05-37245 L  
**SEWAGE DISPOSAL SYSTEM**  
HOWARD COUNTY HEALTH DEPARTMENT  
BUREAU OF ENVIRONMENTAL HEALTH  
410-313-2640

A REPAIR

SUBDIVISION \_\_\_\_\_ LOT NUMBER \_\_\_\_\_ ADDRESS 13214 Highland Road

SITE PLAN  
 13214 HIGHLAND ROAD  
 CLARKSVILLE, (5<sup>th</sup>) DISTRICT  
 HOWARD COUNTY, MARYLAND  
 SCALE 1" = 50'  
 APRIL, 1988

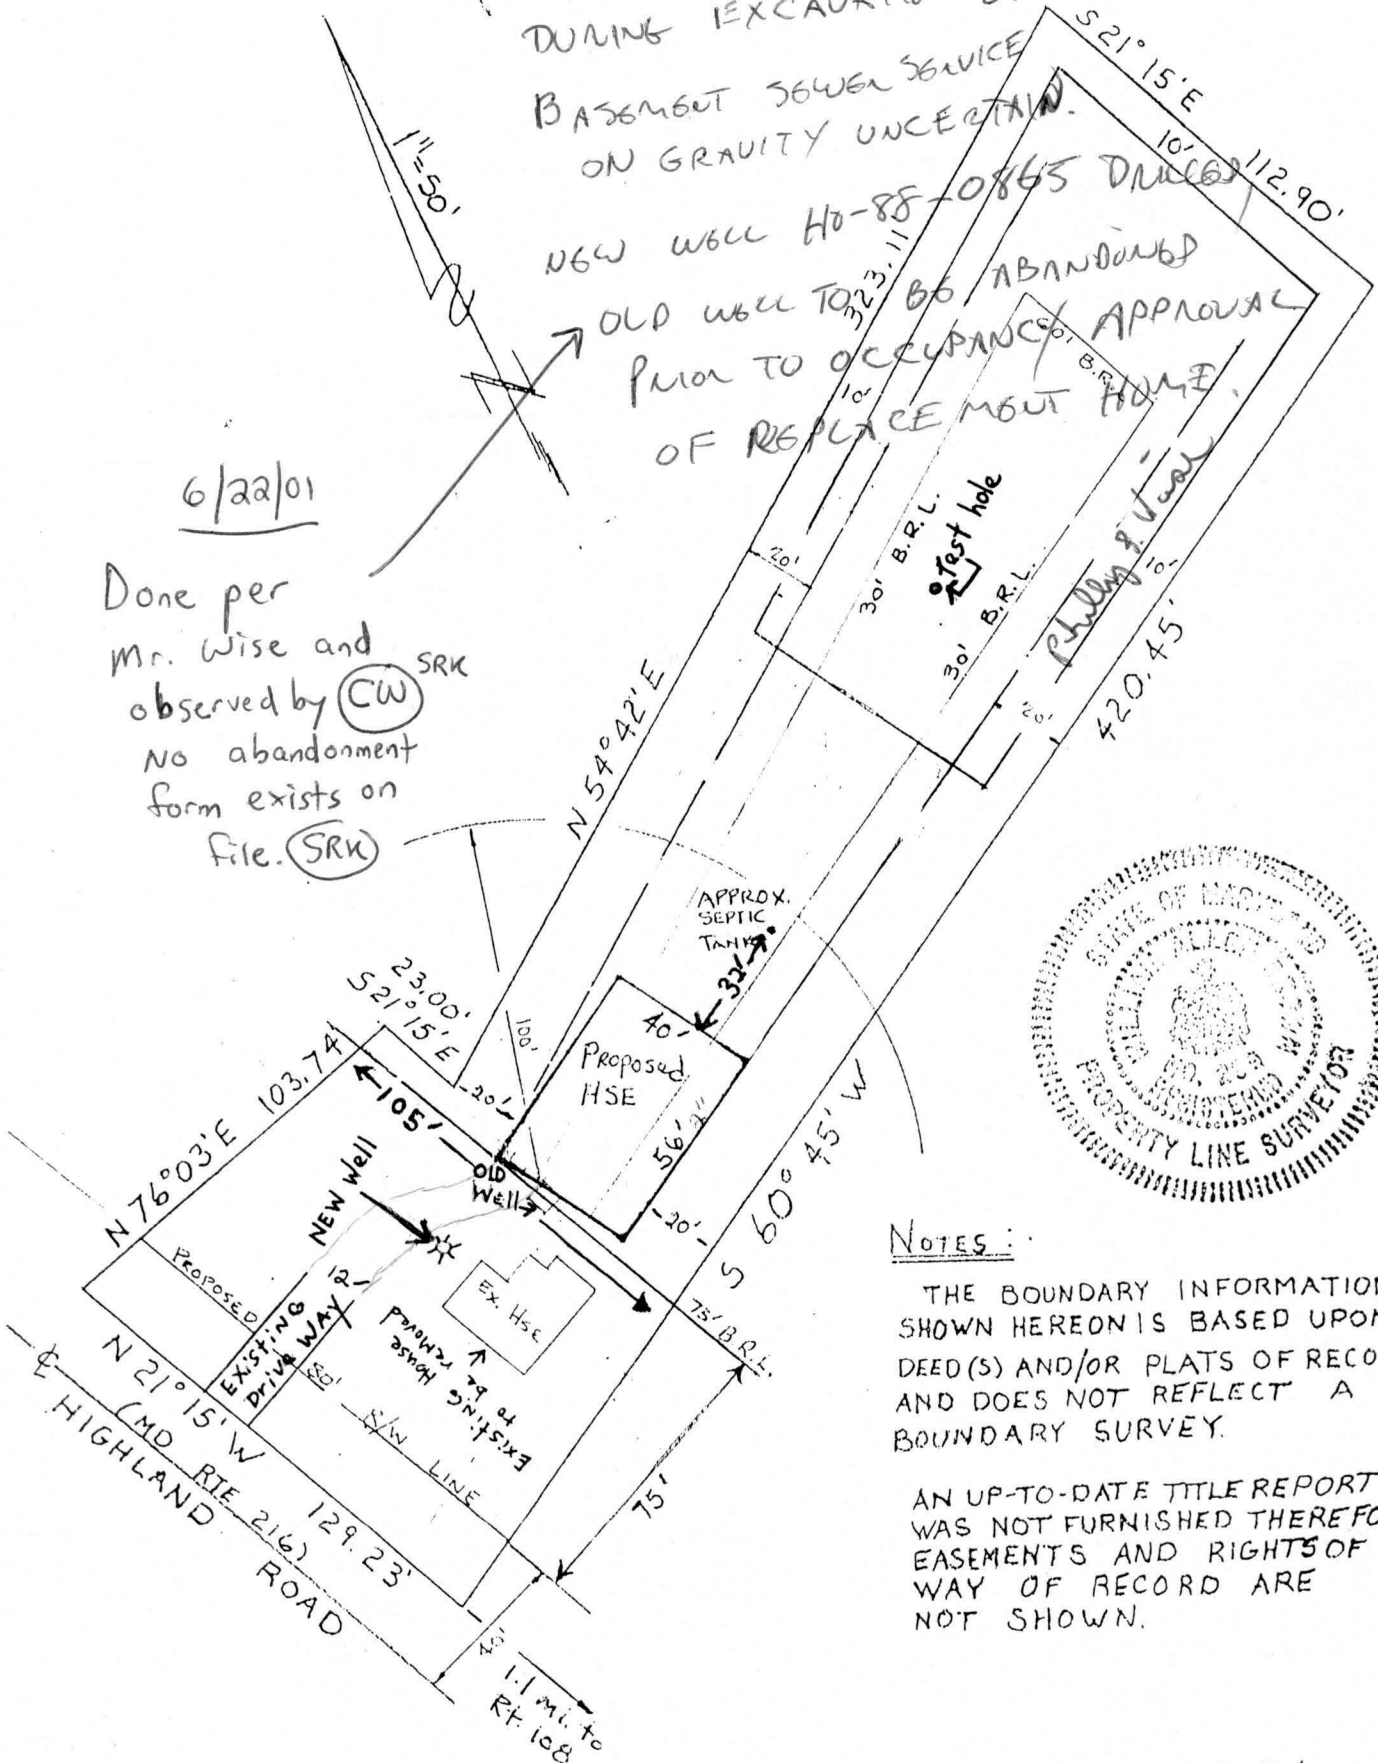
REPAIR - PURPOSE - Existing septic system has failed.  
Call for inspection when ground is opened so sanitarian can recommend repair. 6/26/01

Install Trenches on contour in upper portion of Septic Area. Stay a minimum of 10 Ft from failed leach bed - abandon & fill old septic tanks leach beds because of trees OK to have two trenches of unequal length

Done per  
 Mr. Wise and  
 observed by CW SRK  
 No abandonment  
 form exists on  
 file. SRK
